Model Error Resolution Document

1. Originator: Ernest Hardin	2. Date: 03/18/2008	3. ERD No. ANL-EBS-MD-000033 ERD 01
4. Document Identifier: ANL-EBS-MD-000033 REV 06	5. Document Title: Engineered Barrier System: Physical and Chemical Environment

This document was created for the resolution of 3 TBV's (8783, 8784, and 8786) and 2 CR's (11849 and 11044). This document presents the disposition of the TBV's and CR's, identifies changes to the AMR and evaluates impact on the conclusions of the AMR.

Figure 6.3-5. Representative Repository Drift Locations Selected for the NFC Model

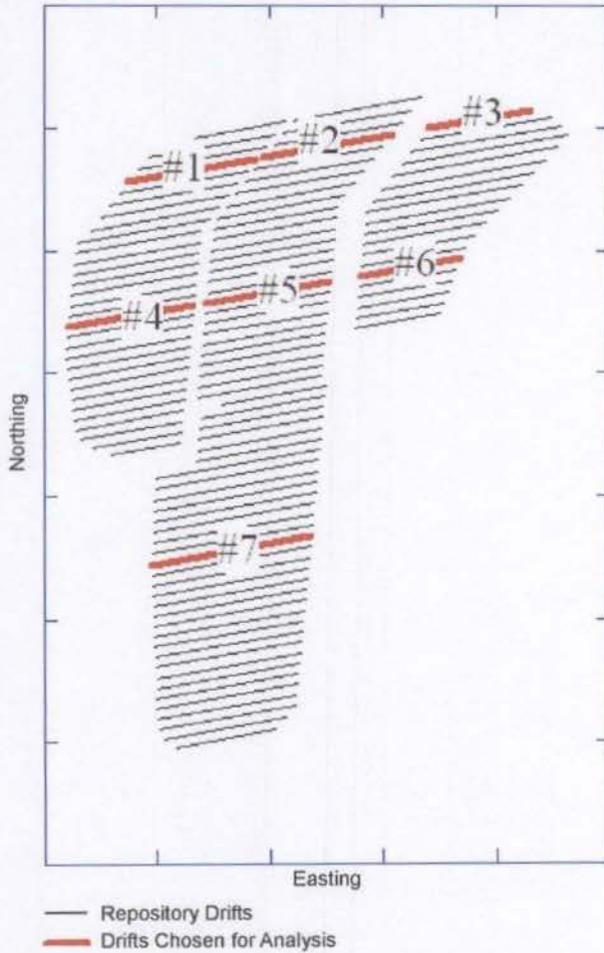
<p>2.) Section 4.1.10, p. 4-14: Changed as follows: Waste package end-point locations are taken from <i>Total System Performance Assessment Data Input Package for Requirements Analysis for Subsurface Facilities</i> (SNL 2007 [DIRS 179466], Table 4-1, Parameter Number 01-01).</p>		
<p>3.) Section 9.1: Add SNL 2007 [DIRS 179466] as follows:</p>		
179466	SNL 2007. <i>Total System Performance Assessment Data Input Package for Requirements Analysis for Subsurface Facilities</i> . TDR-TDIP-PA-000001 REV 00. Las Vegas, Nevada: Sandia National Laboratories. ACC: DOC.20070921.0007.	
<p>4.) Figure 6.3-5: Changed as follows (Note that it was noticed that the figure was an old figure and is being corrected here as well):</p>

NOTE: Drifts defined on the basis of waste package end-point coordinates in SNL 2007 [DIRS 179466], Table 4-1, Parameter Number 01-01.
